# ORIEL WIND FARM PROJECT

## Environmental Impact Assessment Report - Addendum Chapter 5 Addendum: Project Description

MDR1520C  
EIAR – Chapter 5 Addendum  
A1 C01  
December 2025

**Figure 5A-1: Installation of foundations (steps 1-3): 1. Placement of MODIGA and piling of sacrificial casing; 2. Drilling of rock to embedment depth; 3. Removal of drill.**

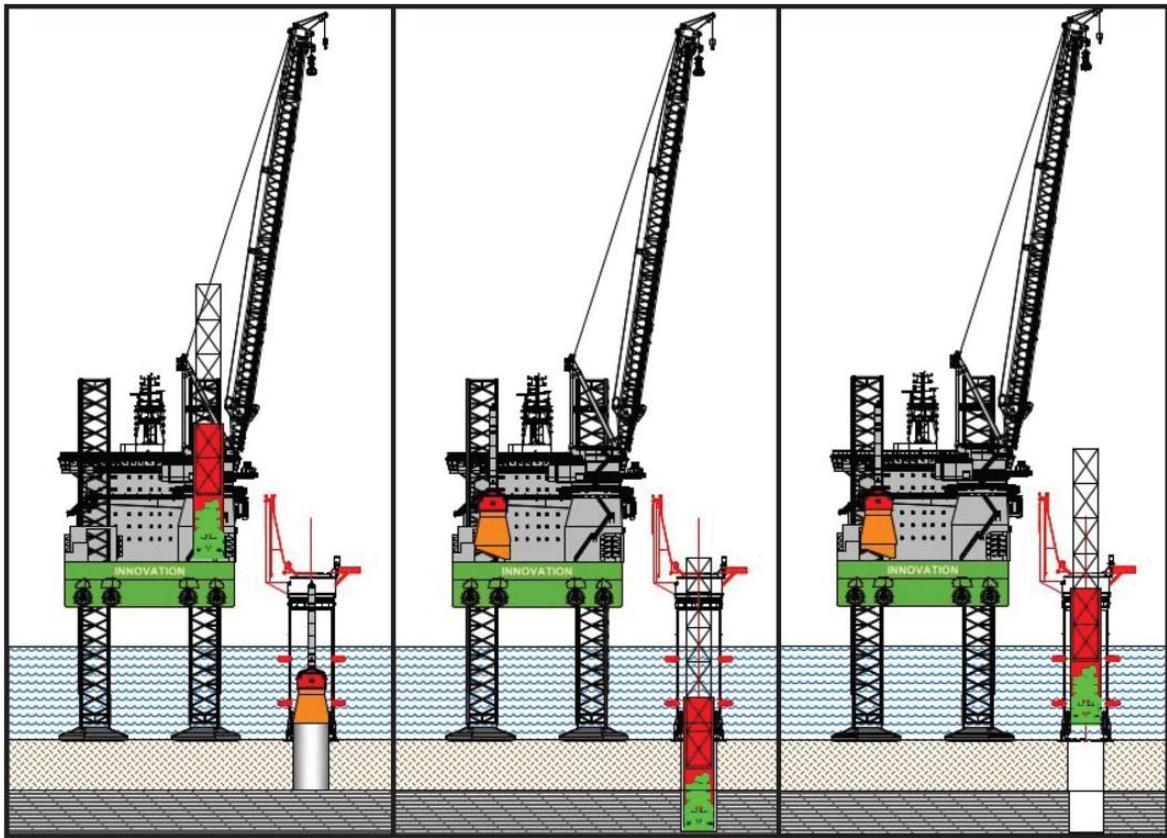
The MODIGA is lowered to the seabed from the installation vessel and initially a sacrificial casing is inserted. The hammer piling tool is then inserted into the tool and the sacrificial casing is hammered through the unconsolidated sediments to its resistance limit which is expected to be at or close to the rockhead.

A short duration (up to a maximum of 8 hours per foundation) is required for stabilisation of a sacrificial casing within less competent seabed material (sands, gravels, boulder clays) prior to commencement of drilling within the sacrificial casing.

The drill is inserted inside the sacrificial casing, the rock is drilled out to the required embedment depth. On completion of drilling, the drilling tool is removed and the monopile is inserted into the drilled hole. The annulus between the drilled hole and the monopile is then sealed with a grout.

A sequence of graphics detailing the foundation installation sequence is provided in Figure 5A-1 and Figure 5A-2.
